ARBORICULTURAL APPEAL STATEMENT

**Abbots Leigh
Washington Road
Storrington
RH20 4AF**

Document ref: PJC/6801/25-01 Rev -

Appendix 1: Proposed Levels Plan

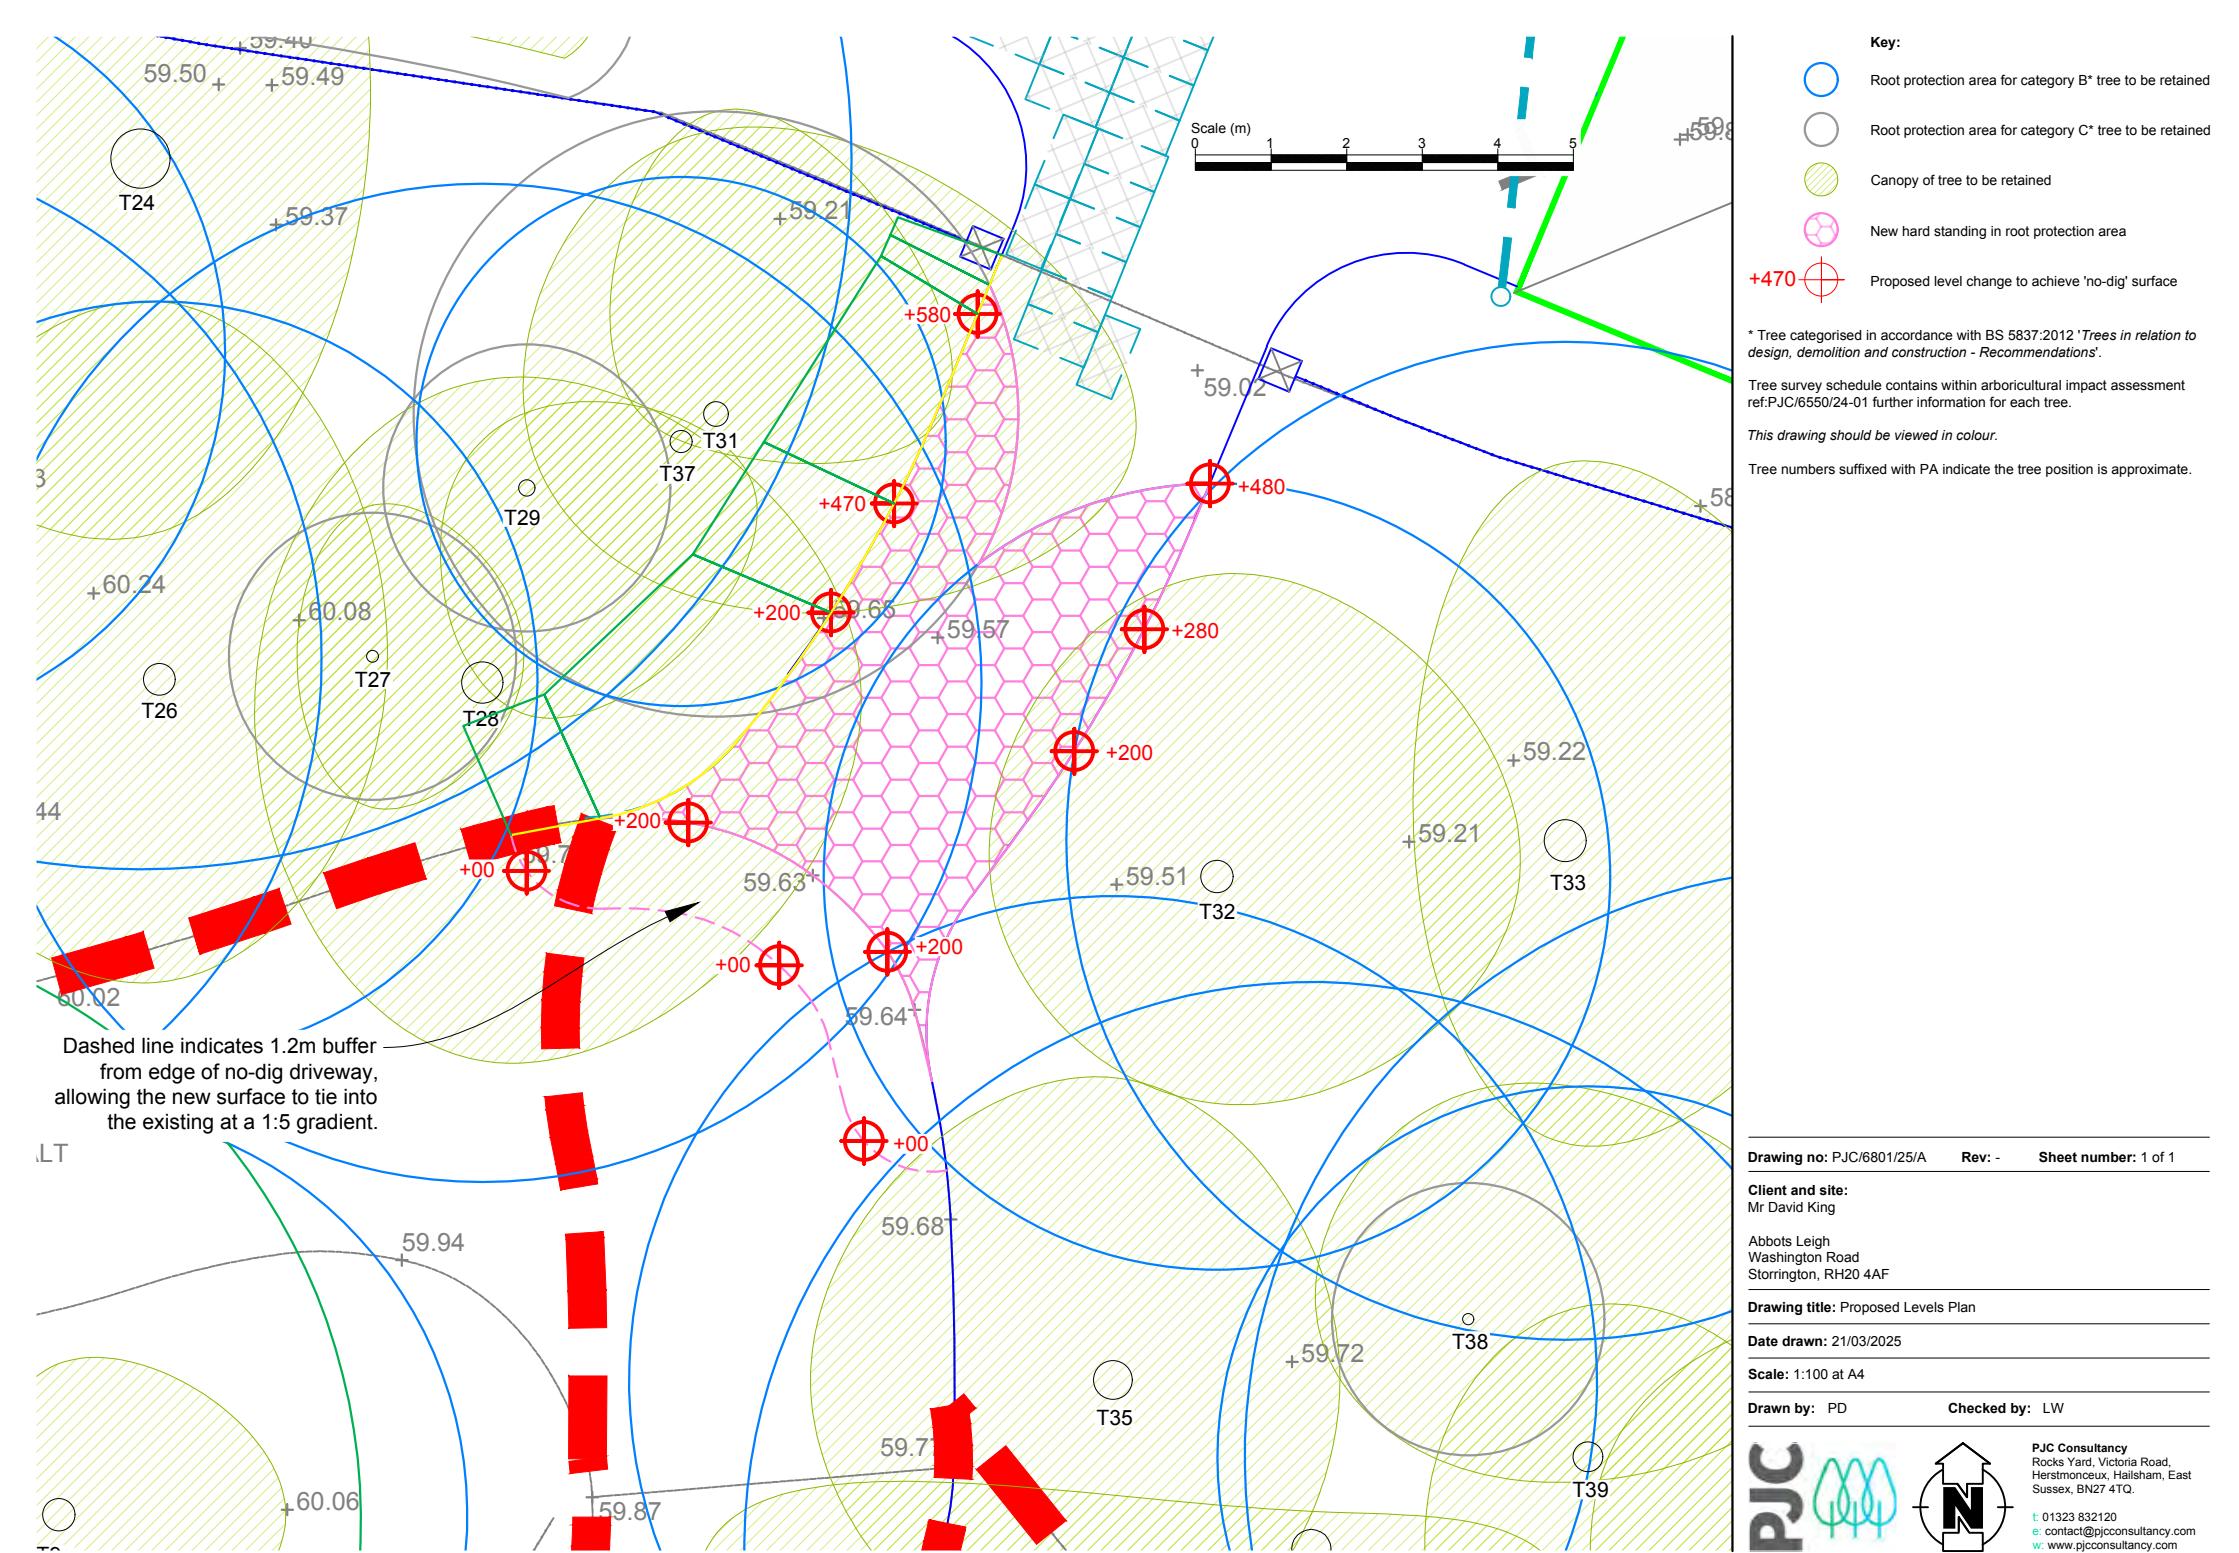
The area where the new access is proposed is not currently level ground, and it is not possible to implement this aspect of the development without the need for some excavations and ground levelling works within the RPA of the affected trees. The PAMS in para 4.8.2 refers to the need to remove the topsoil layer to allow for the new access to tie into the level of the existing driveway and advises that the works would be completed under Arb supervision, and by hand, but the extent and depth of the excavations has not been mentioned in the document. It is acknowledged that the extent of the development proposed with the RPA of the affected trees T28, T31, T32 and T37 doesn't exceed the maximum 20% allowance set with the BS. However,

due to vast differences in land levels where the access is proposed it would imply that substantial ground preparation works would be needed, even if the works are completed under supervision and by hand this action, in my opinion, is likely to result in root severance and damage to the affected trees. From the submitted info the PAMS doesn't appear to demonstrate that the impacted tree(s) can remain viable following the works, it doesn't propose a series of mitigation measures to improve the soil environment of the affected trees, nor does it provide any justification for why the access needs to go through the belt of trees; additional info is needed.

2.2.4 A survey string was pinned to the ground at the upper level of no-dig road at 200mm above the existing ground level, which should be sufficient to construct a gravel driveway on a 150mm Cellweb TRP cellular confinement system. The string was then tied to the boundary fence at a suitable level to enable the height of the no-dig road build up to be recorded. The proposed level changes are shown on the Proposed Levels Plan at Appendix 1. These range between 200mm at the relatively level part of the driveway up to 580mm it is lowest point on the west side of the driveway (480mm on the east side).

- 2.3.4 In a modification to the proposal within the arboricultural impact assessment that accompanied the refused planning application, the new driveway will no longer tie into the level of the existing driveway. Instead, the level of the existing driveway will be built up at a gradient of 1:5 for approximately 1.2m (depending on file driveway specification) to tie into the level of the proposed 'no-dig' surface, thus avoiding the need for excavation at the edge of the existing driveway.
